SERVICE BULLETIN M20-276

SUBJECT: OVERHEAD TUBULAR STRUCTURE MODIFICATION

MODELS/ S/N  
AFFECTED: M20J, Serial Numbers 24-3374 thru 24-3431  
M20K, Serial Numbers 25-2000 thru 25-2032  
M20M, Serial Numbers 27-0181, 27-0184 thru 27-0306, 27-0308  
M20R, Serial Numbers 29-0001 thru 29-0254  
M20S, Serial Numbers 30-0001 thru 30-0057

Figure M20-276-1

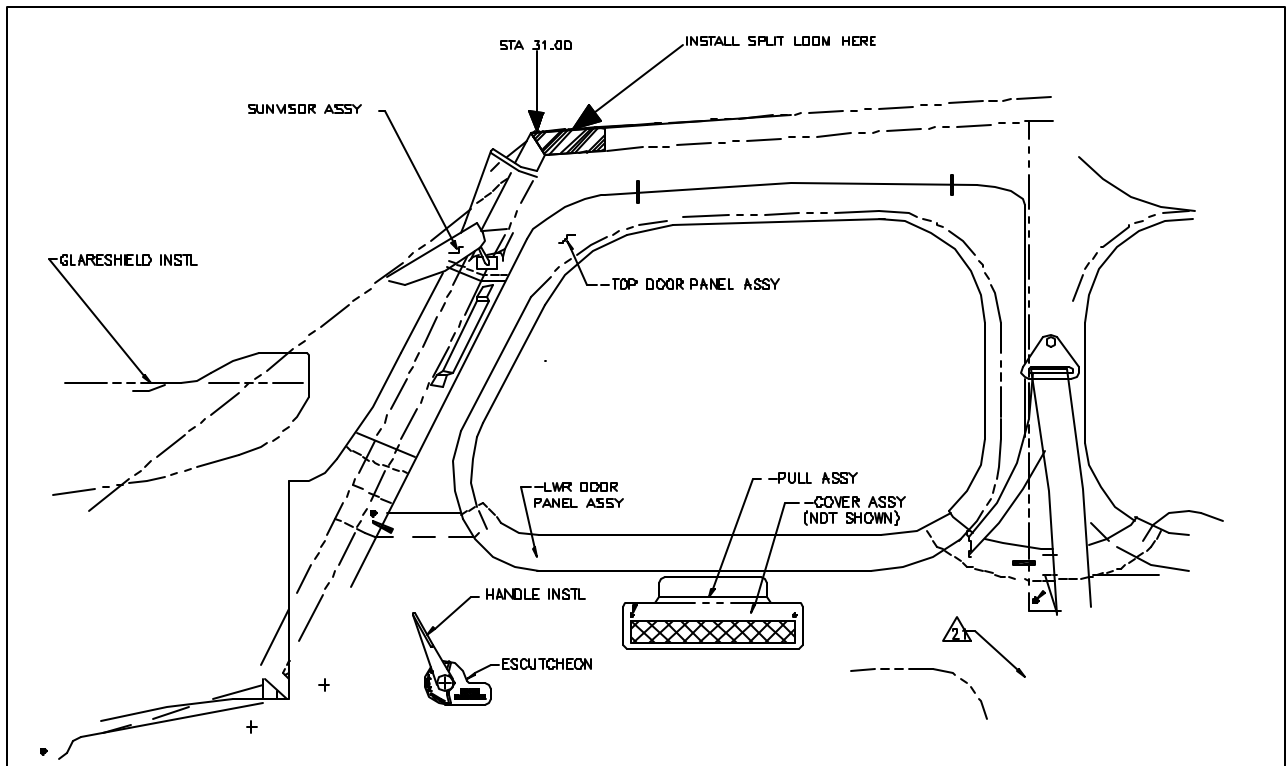
2. Drop headliner assembly down far enough to access overhead tubular structure (figure M20-276-1 (black arrow)).
3. Inspect electrical wiring connection area associated with the headliner forward switches (figure M20-276-1 (white arrow)) for evidence of arcing and replace any affected components, as necessary, per the individual aircraft's Service and Maintenance manual.
4. Insert a 3 inch long piece of 1.000" black heat stabilized nylon split loom tubing between station 31.00 and 34.00 (figure M20-276-2) on the overhead tubular structure, which runs down the middle of the headliner assembly.
5. Secure split loom tubing to overhead tubular structure with nylon wire ties as required (figure M20-276-3).
6. Reinstall headliner assembly per respective aircraft's Service & Maintenance Manual.
7. Reconnect battery(s) to aircraft.
